MONTGOMERY COUNTY HISTORIC PRESERVATION COMMISSION
STAFF REPORT

Address:	10201 Menlo Ave.	Meeting Date:	12/20/17
Resource:	Contributing Resource Capitol View Historic District	Report Date:	12/13/17
Review:	HAWP	Public Notice:	12/06/17
Case Number:	37/07-17G (continued)	Tax Credit:	None
Applicant:	Minter Farnsworth	Staff:	Dan Bruechert
Proposal:	New Construction

PROPOSAL

SITE PLAN
1" = 20'

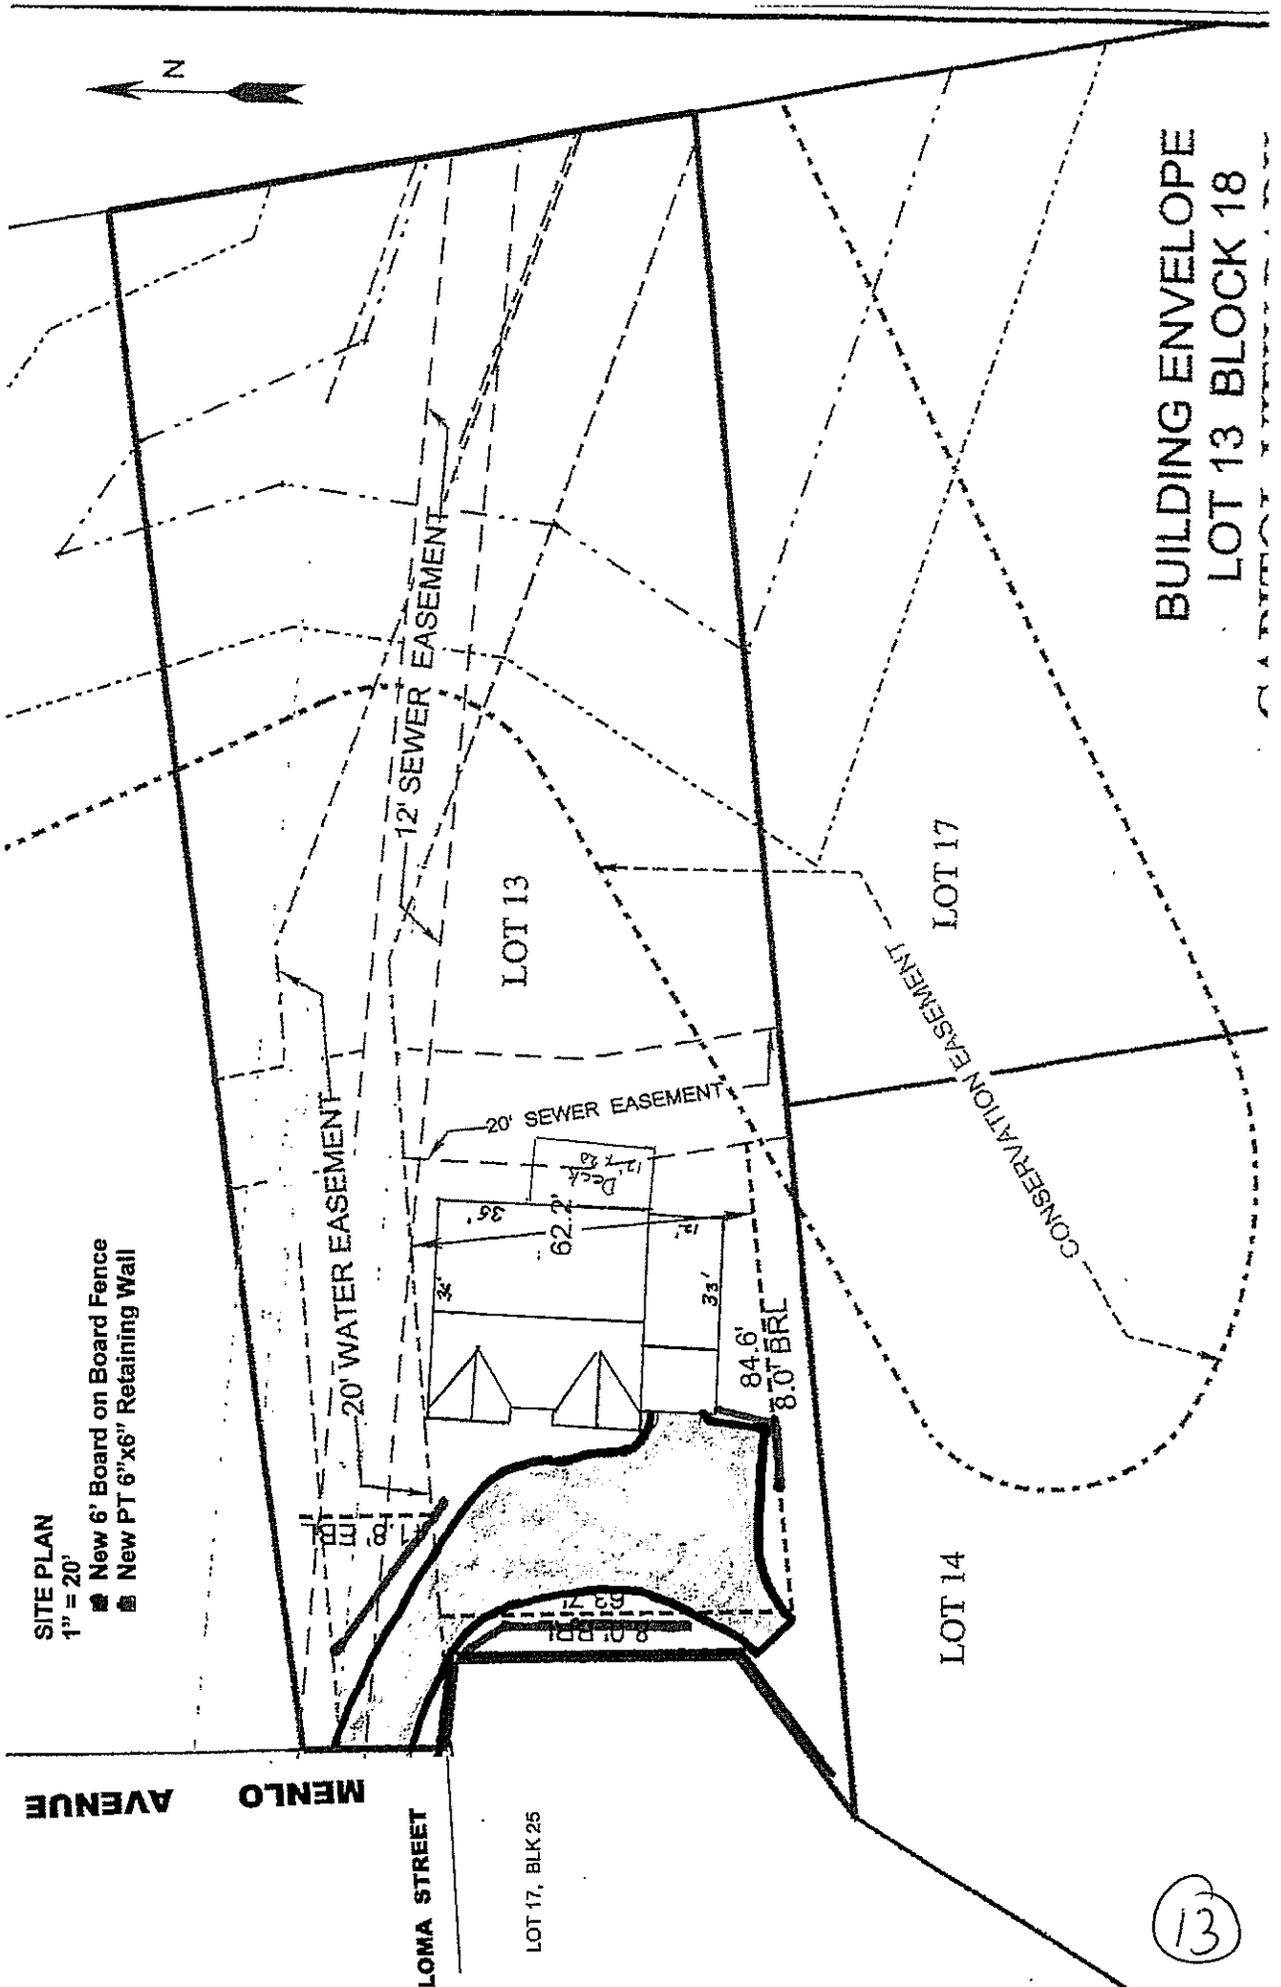
The applicant is proposing to install a six foot (6') tall, wood, board on board privacy fence placed at the front boundary of the property. The HPC does not typically approve fences taller than forty-eight inches (48") in front of the rear wall plan within historic districts. The neighboring property has a fence that is approximately five feet (5') tall, which would intersect the proposed fence at the middle. The southern half of the proposed fence will be obscured by the neighbors existing fence and will not be visible. The northern portion of the fence will be visible from the public right of way and staff believes that due to the unique siting of the lot, a solid board on board design is acceptable, however, the fence height should be reduced to 48" (forty-eight inches) to the north of the neighbor's wooden fence. The fence plan is shown below.

FRONT ELEVATION
1/4" = 1'

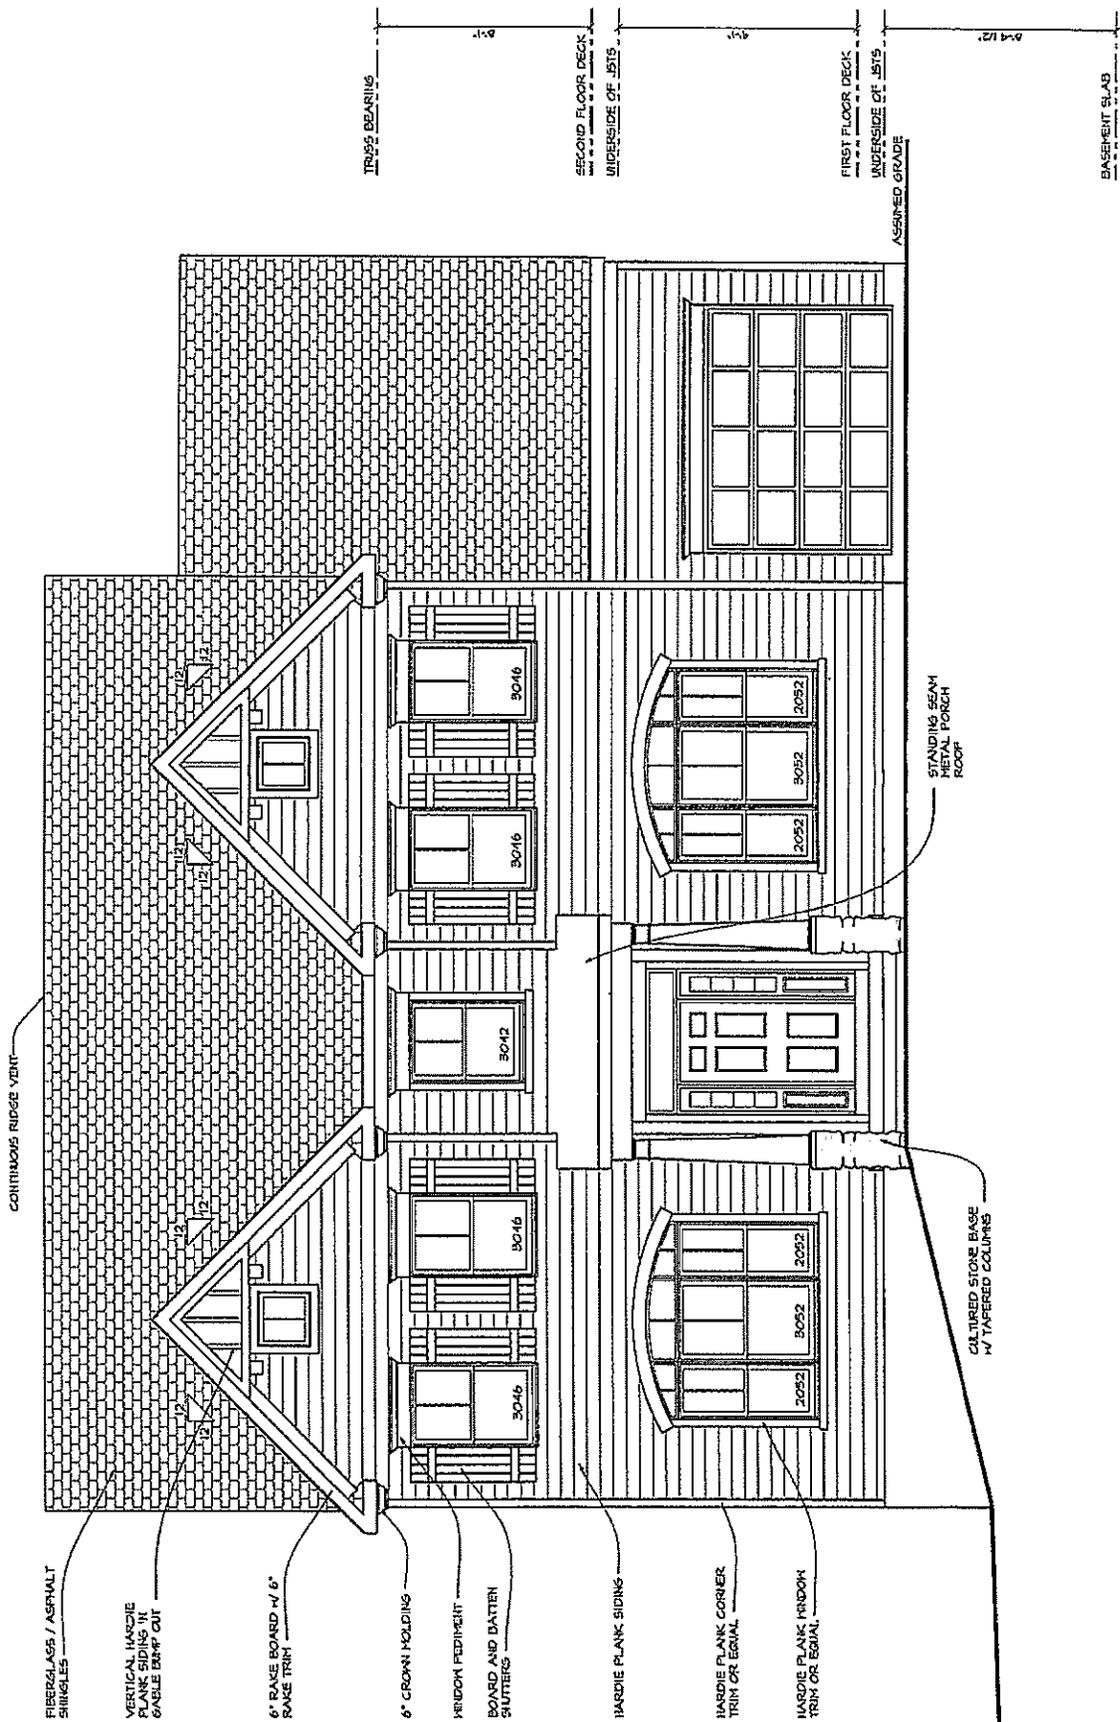
The applicant did not provide windows specifications with the application materials. Staff feels that the proposed one-over-one configuration is acceptable, and recommends the HPC condition approval on the applicant using a wood or clad windows.

1. The proposed windows must be either wood or clad. Details need to be submitted to Staff for review and approval with final approval authority delegated to staff.
2. Placement and species of the new trees needs to be submitted with permit drawings for review and approval with final approval authority delegated to Staff.

REAR ELEVATION
1/4" = 1'

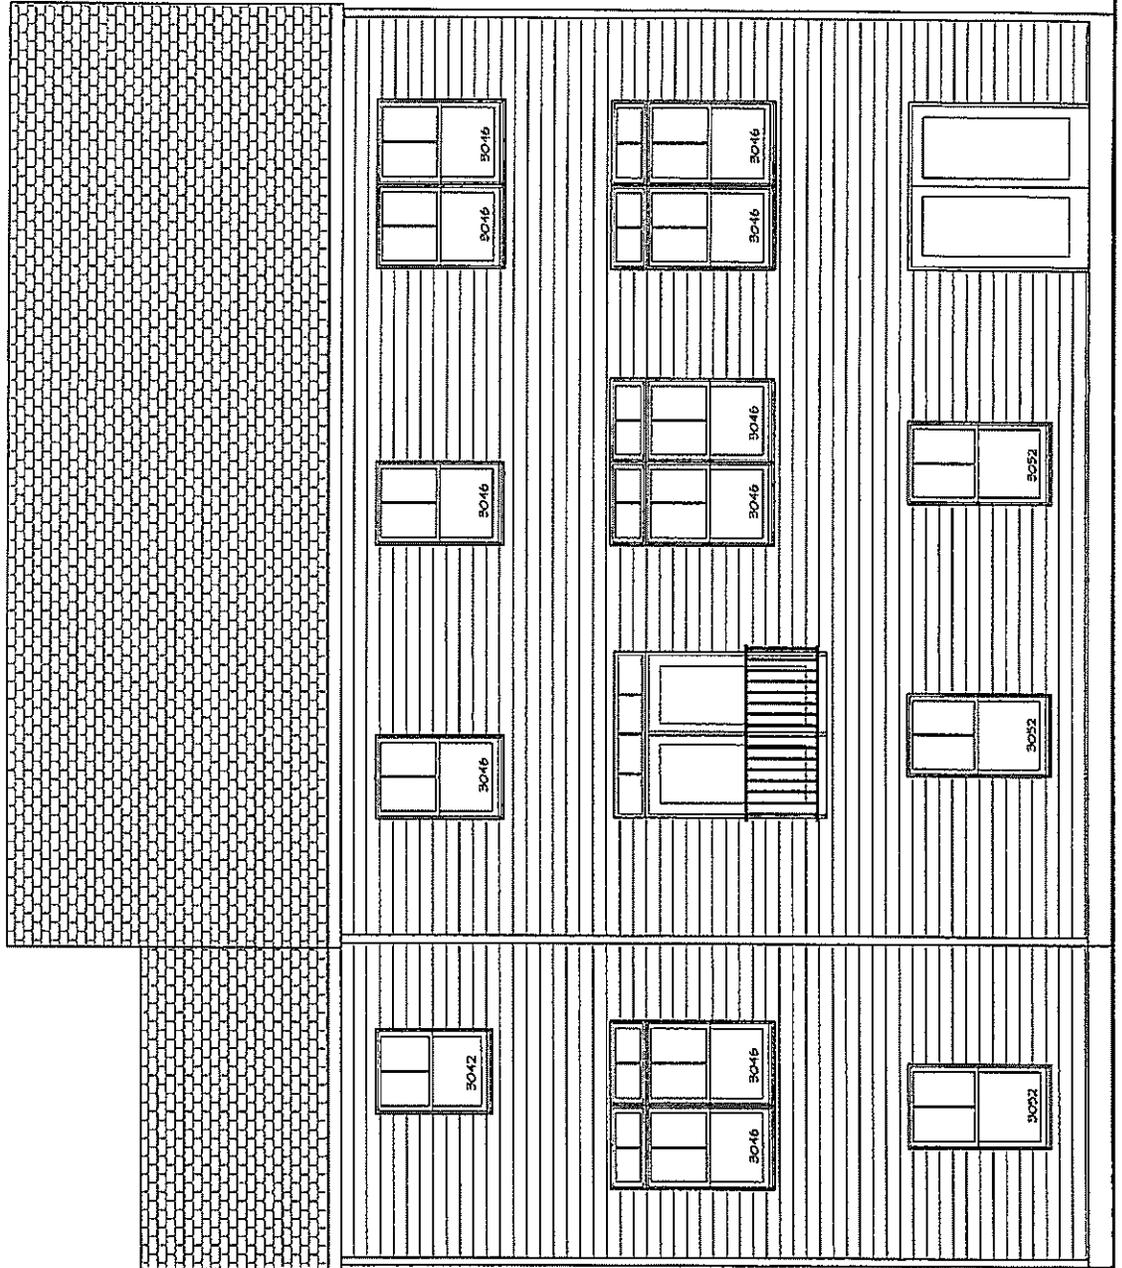
The applicant proposes to construct a 12' × 20' (twelve feet by ten feet) deck to the rear. The applicant proposes to construct the structure of the deck out of wood, with a composite decking material, azek trim, and “Wolf” metal rails. Staff feels that the composite decking and azek trim are acceptable substitute materials in this location due to the fact that their characteristics are similar to wood. Staff also feels that the metal balusters are acceptable in this location because the deck is at the rear on new construction. As this it is on the rear of the house and the conservation easement and additional buildings will obscure its visibility from the public right-of-way, Staff believes this decorative element should be approved.
